Concerned Products:	Customer Notification		Date: Jan. 28, 1998
			NEC-Electronics (Europe) GmbH EAD -Technical Product Support
IE-789026-NS-EM1	Bug Report		Source Doc: SBG-T-0442 SBG-T-0487 SBG-T-0524 SBG-T-0603
			Author: W. Noll M. Kratz
	Jan. 28th, 98	Doc. No.:	TPS-LE-B-ST02
1 st revision:	May 11th, 98	Doc. No.:	TPS-LE-B-ST02
2 nd revision:	June 4th, 98	Doc. No.:	TPS-LEB-ST02

(A) BUG LIST

Figure P50 Block Diagram

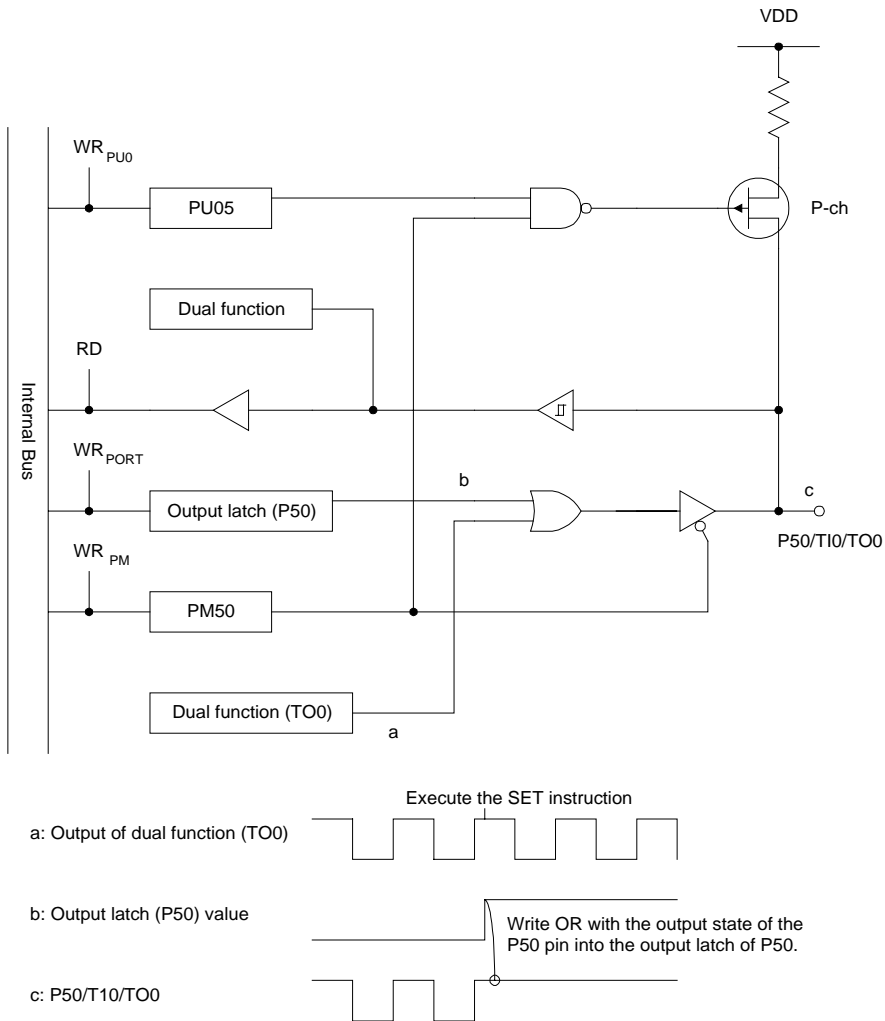
Bug No.	Outline	Description
1	Bit and logical operation at ports 2 and 5	<p>Details</p> <p>Avoid to use bit operation instructions and logical operation instructions on Ports 2 and 5(dual function pins). Instead of this, be sure to use 8 or 16-bit data transfer instructions to control output ports 2 and 5.</p> <p>Reason for operating precautions Executing bit operation instructions (SET1, CLR1) and logical operation instructions (OR, XOR, etc.) on the ports (2 and 5) which have the dual functions of timer output and serial interface may cause the contents of the dual function pins to be different from the expected values. This is because the bit operation instructions and logical operation instructions of the μPD789025, 789026 and 78F9026 are not for performing operations on the contents of the output latch but for performing operations on the status of the relevant pins.</p> <p>We have no plans to change the device circuits.</p> <p>For your reference, Attachment 1 shows an example of executing the SET1 instruction on P52 causing P50 to be fixed to "H" and Attachment 2 is listing the ports and instructions relevant to this precaution.</p>

- ① Uses P50 as the TO0 output to execute “SET1 PORT 5.2” while TO0 is outputting a high level.
- ② The CPU reads all the pin statuses of Port 5 in response to the SET1 operating instruction, sets the relevant bit (P52 in this example) and writes the result to the latch of the Port 5.
- ③ When this SET1 instruction was executed, pin P50 was high level. This results in a high level being written to the output latch of P50, thus causing the pin’s output to be fixed to high level. (When outputting TO0, it is necessary to set the output latch to low level first.)
